PROJECT NAME: FRANKLIN
PROJECT NUMBER: STP 030(18)

FILE NAME: /str/B5c060/s85c060ww.dgn PLOT DATE: 21-MAR-2003
PROJECT LEADER: S. FARNSWORTH DRAWN BY: R. PELLET
DESIGNED BY: M. FOWLER CHECKED BY: G. PILAK
s060ww15282.1 SHEET 25 OF 60

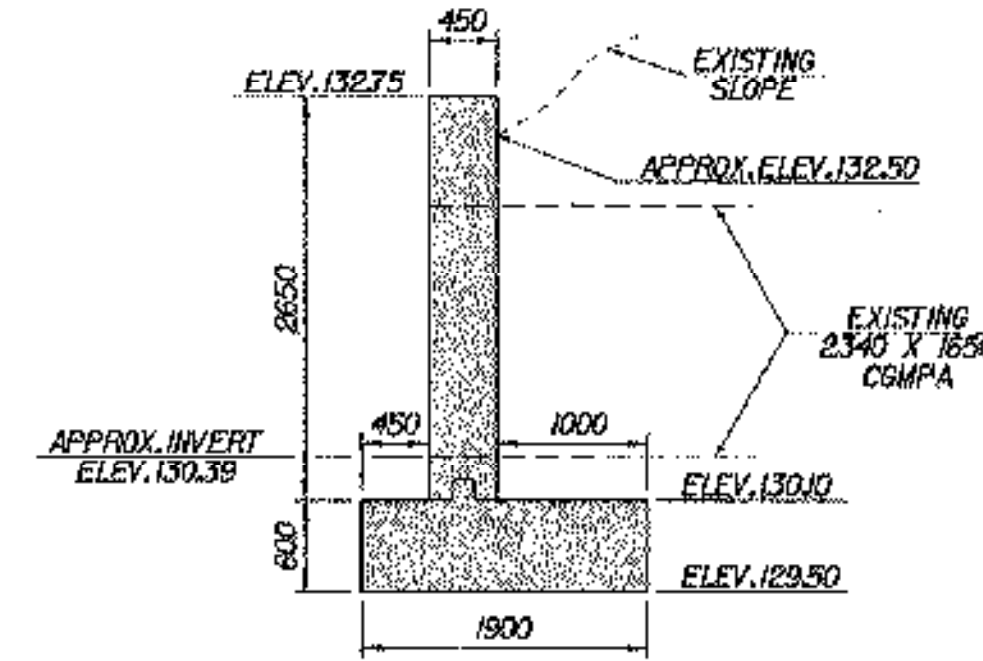
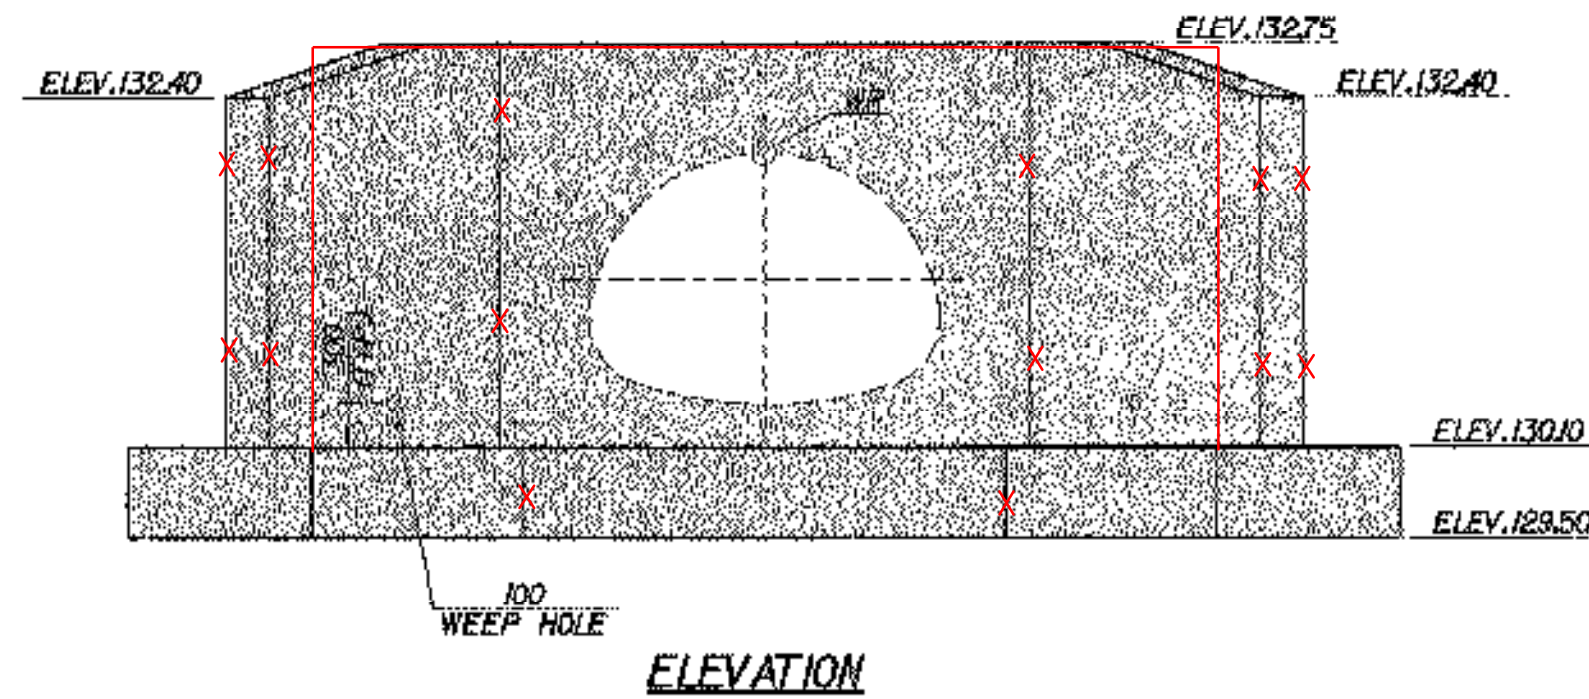
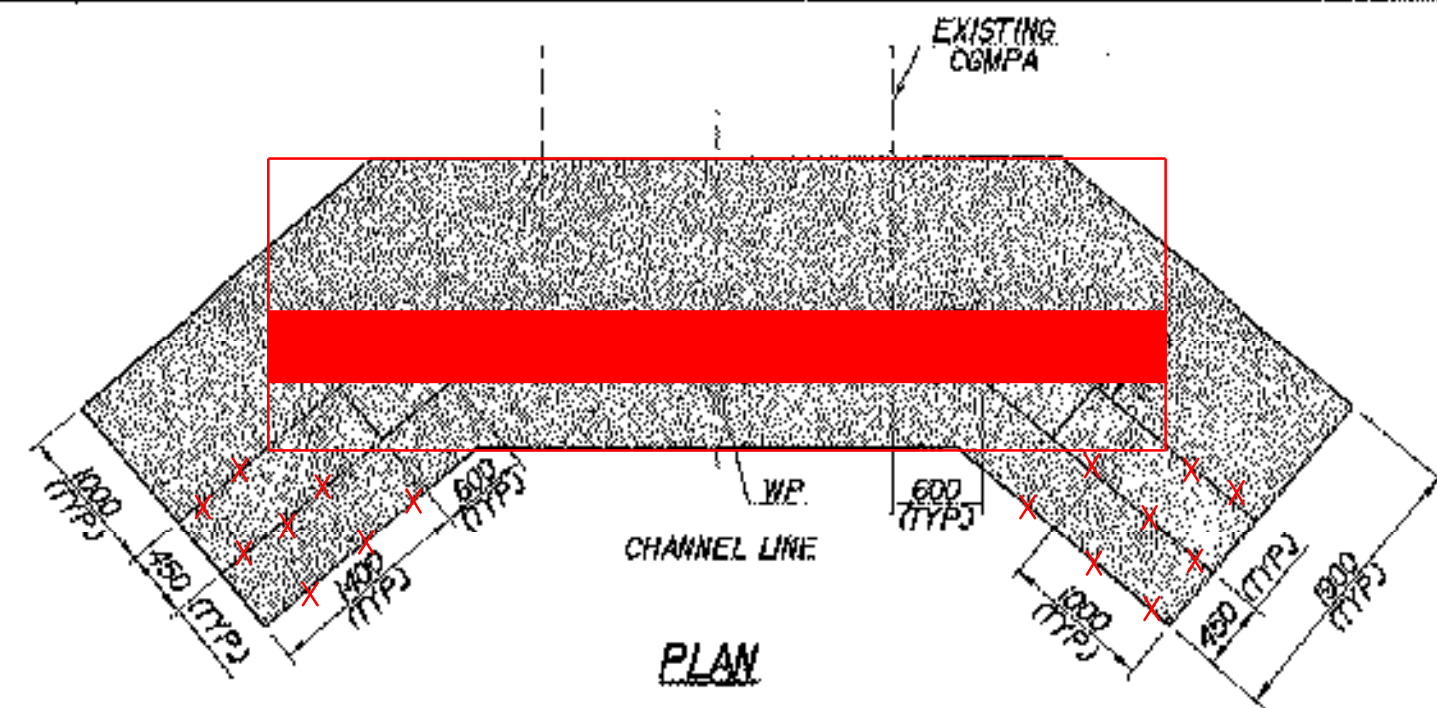
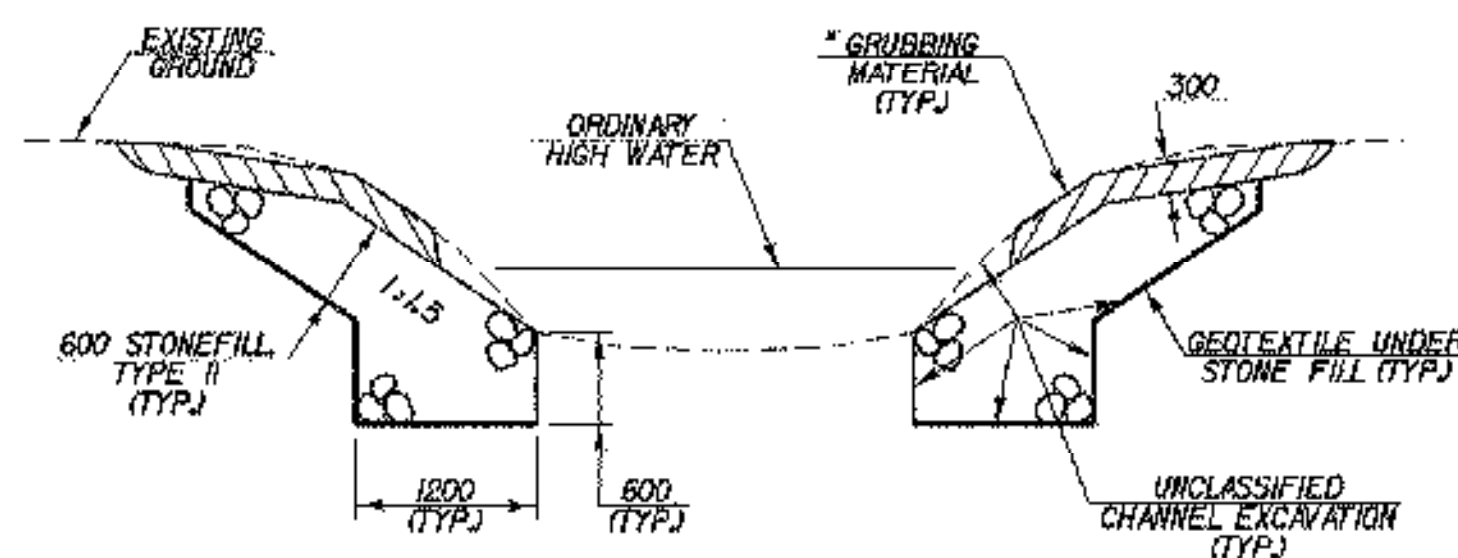
• CHANGE TO STRAIGHTEN HEADWALL
BECAUSE OF WATERLINE CONFLICT
